high level nuclear waste office

May 28, 1985

Enclosed are Appendices A through J and Bibliography as submitted by the State of Utah to the Department of Energy as part of the comments package to the Draft Environmental Assessments for Davis and Lavender Canyon Sites.

Figure 3: Hydraulic conductivity tests from GD-1.

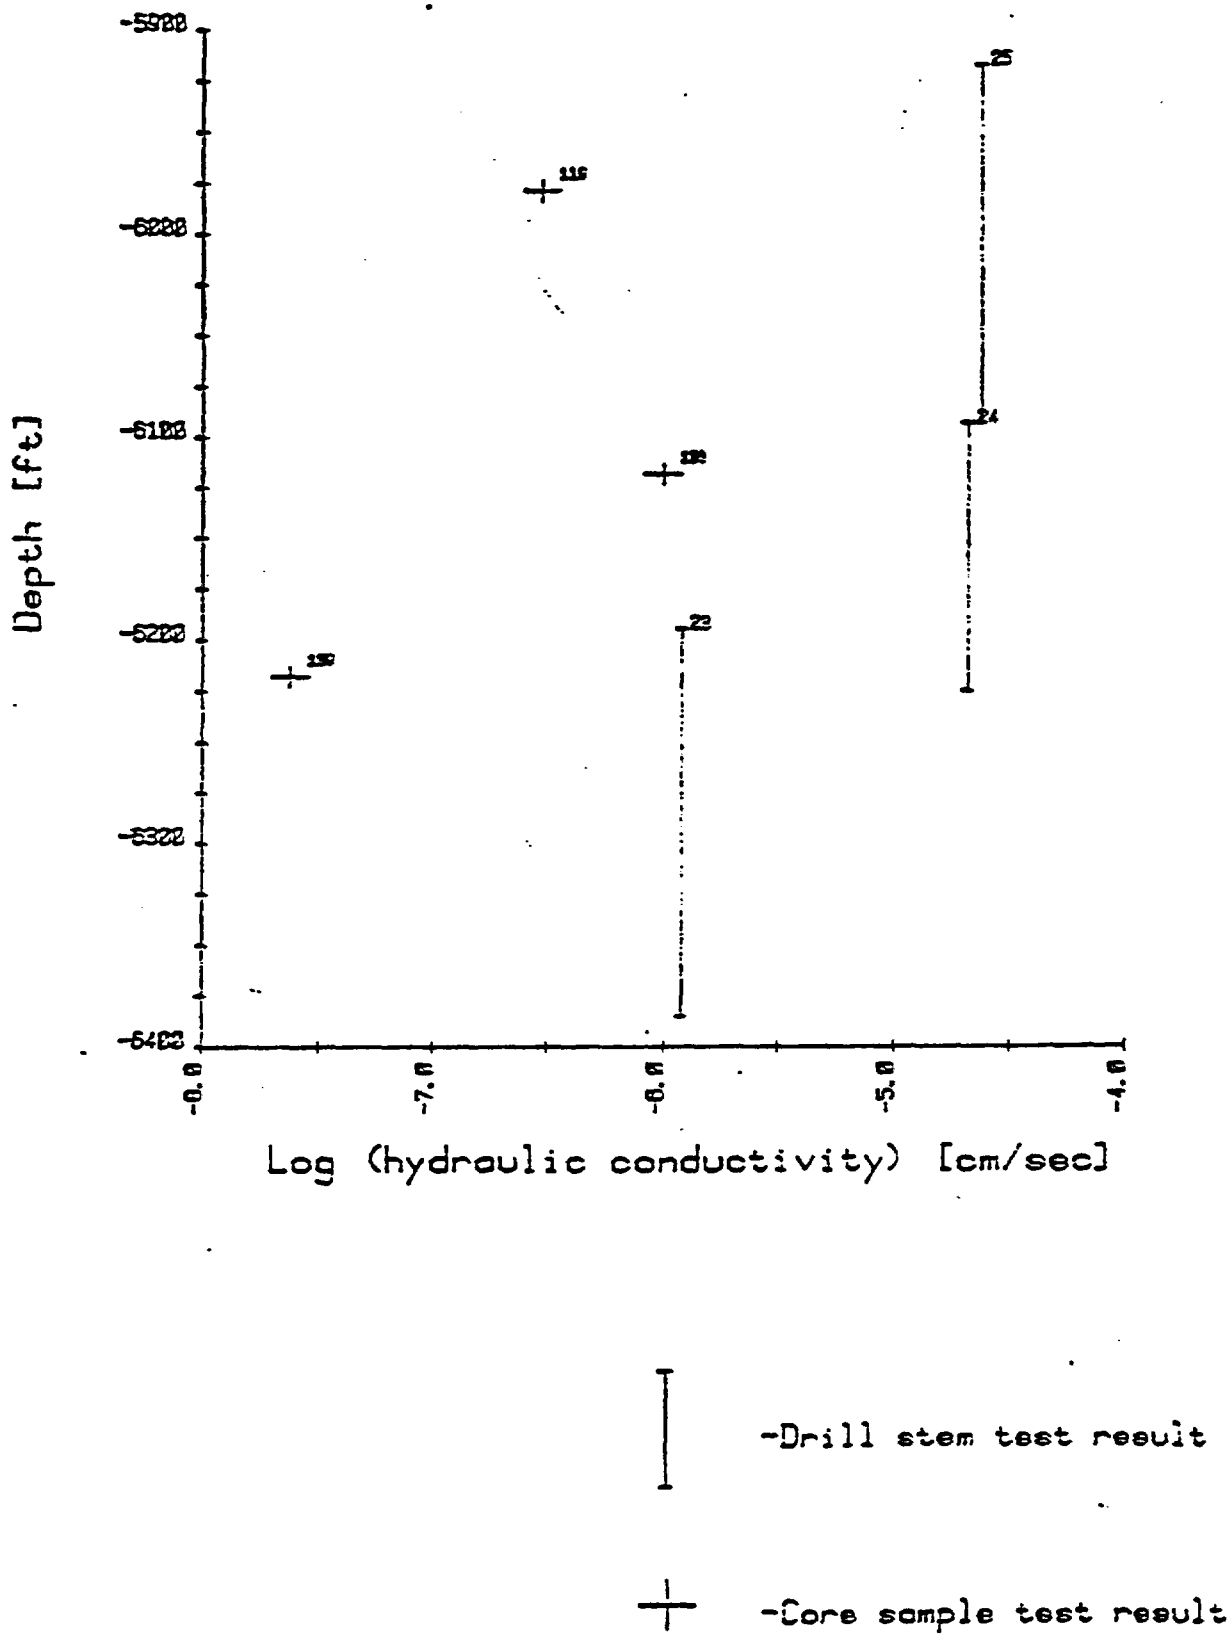
Fractures do occur in the GD-1 core in several formations. Principle among these is the Leadville Limestone. Comparison of the lab and field permeability tests indicate that the field tests yield permeabilities one to two orders of magnitude larger than the lab samples (Figure 3). The lab samples provide a measure of the matrix permeability, whereas the field drill stem tests give the permeability of the bulk rock including secondary features. The consistently higher permeabilities obtained by the drill stem tests in the Leadville Limestone indicate that secondary permeability controls the groundwater flux through this unit. This was also noted by the contractors conducting the permeability tests for DOE (Thackston et al., 1984). The nature of the secondary permeability has not been studied, but examination of the GD-1 core log (Woodward Clyde Consultants, 1982) suggest that the Leadville is generally homogeneous and contains a number of widely spaced open fractures. The secondary permeability is likely the result of these fractures. If this is the case, using the matrix effective porosity to calculate groundwater velocities, as done by the DOE modelers, is clearly erroneous. Some fracture flow model is necessary to calculate correct velocities from the assumed

The permeability data in the lower Paradox formation does show a large discrepancy (two to three orders of magnitude) between core samples and borehole tests which may be indicative of secondary permeability. But these results are complicated by the effects of salt squeeze in the borehole tests.

Figure 1

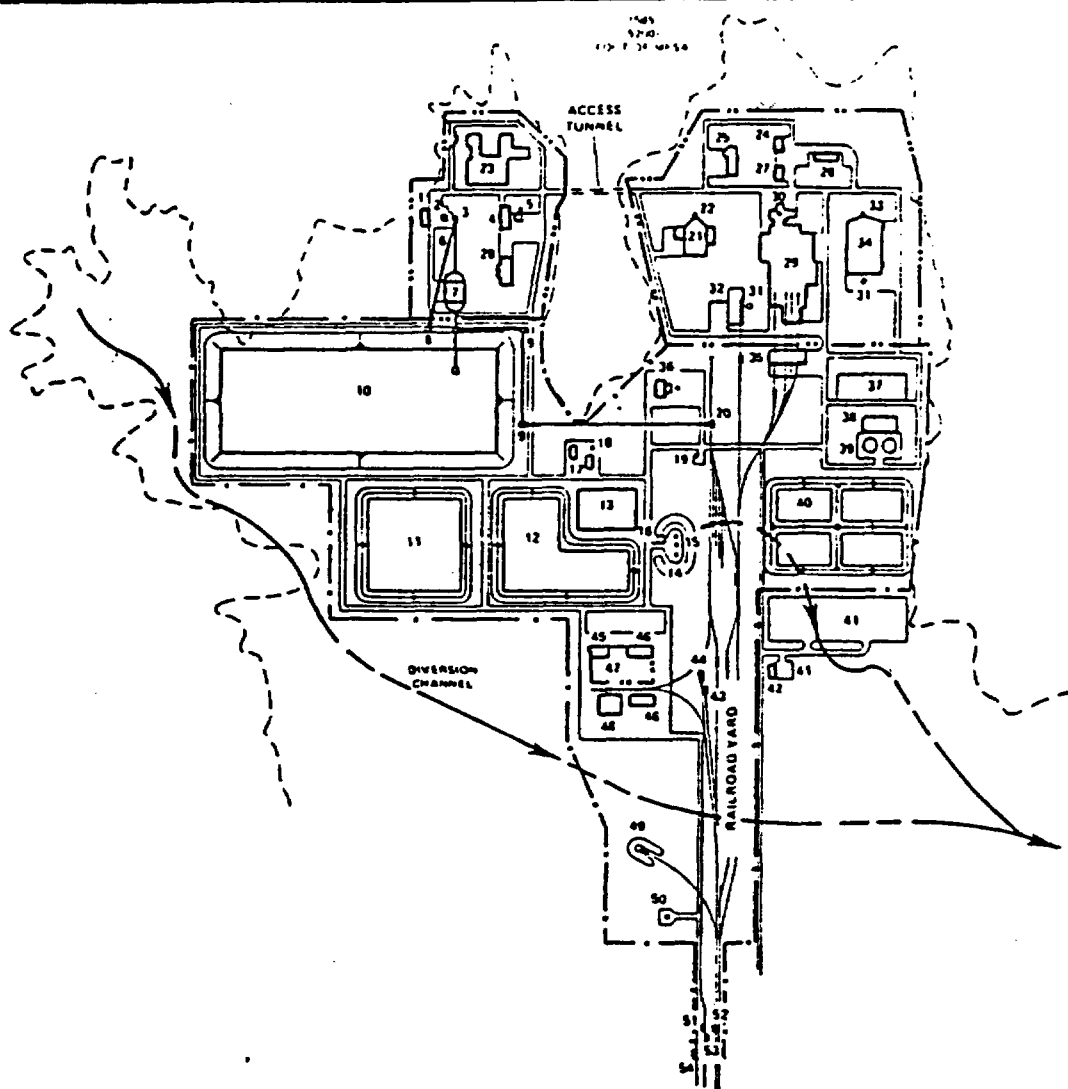
structures were tested for visibility from both ground level and at their maximum height. They were (1) the service shaft headframe (maximum height of 220 feet), (2) the group of buildings near the middle of the site plan described as the maintenance building complex (maximum height of 30 feet), and the meteorological tower (maximum height of 198 feet) located at the extreme southern end of the site. Figure 1 illustrates their location in the proposed Davis Canyon site plan.*

* This is a revision of the site plan used in the 1983 study. As a result, time was taken to revise portions of that study concurrently. The opportunity was also taken to reconstruct the maps presented in the 1983 study to comply with the format used in the current review. The revised 1983 maps and the summary statistics of that study are also presented in the results section.

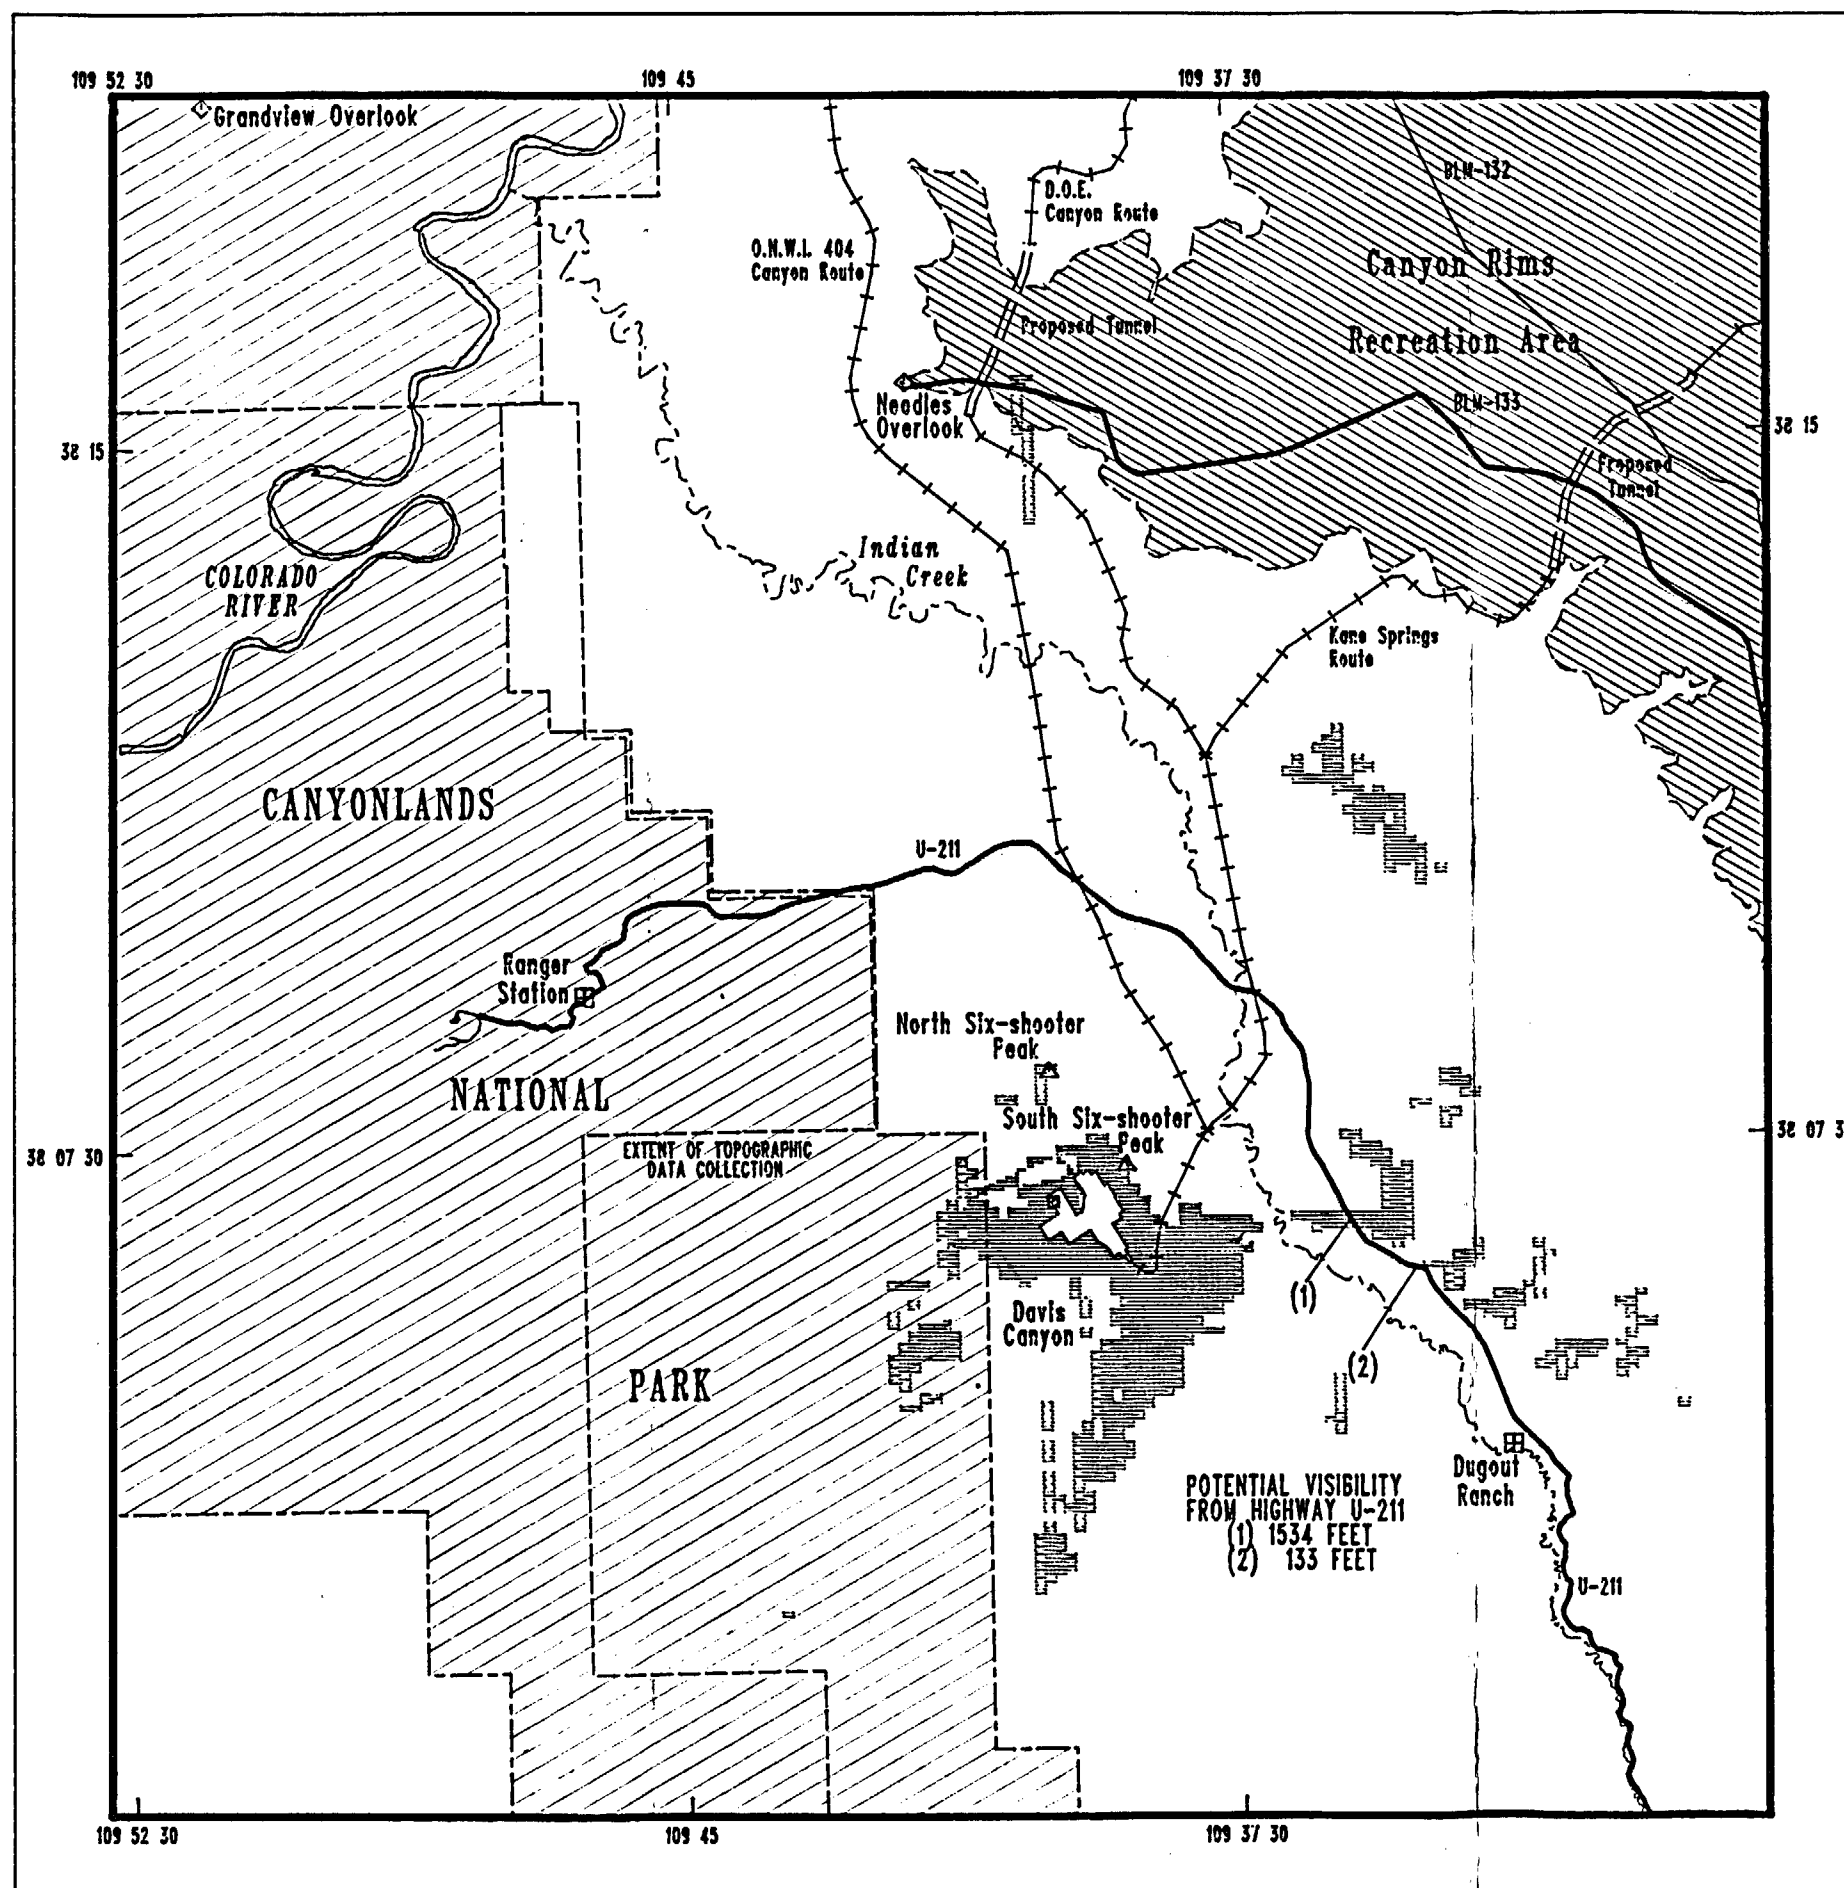
In sharp contrast with the ONWI 454 results, this review shows that the Davis Canyon site is visible from Utah Highway 211. Proposed repository structures would be visible both at ground level and at their maximum height. A companion finding (which may even more interesting) is the indication that some of the proposed structures might also be visible from the road which terminates at Needles Overlook inside the Canyon Rims Recreation Area. In particular the tests on the meteorological tower and the maintenance building complex indicate potential visibility.

An element of inconsistency is found when comparing sections of the Fifth Draft of the EA with ONWI 454. ONWI 454 concludes that "a structure...would
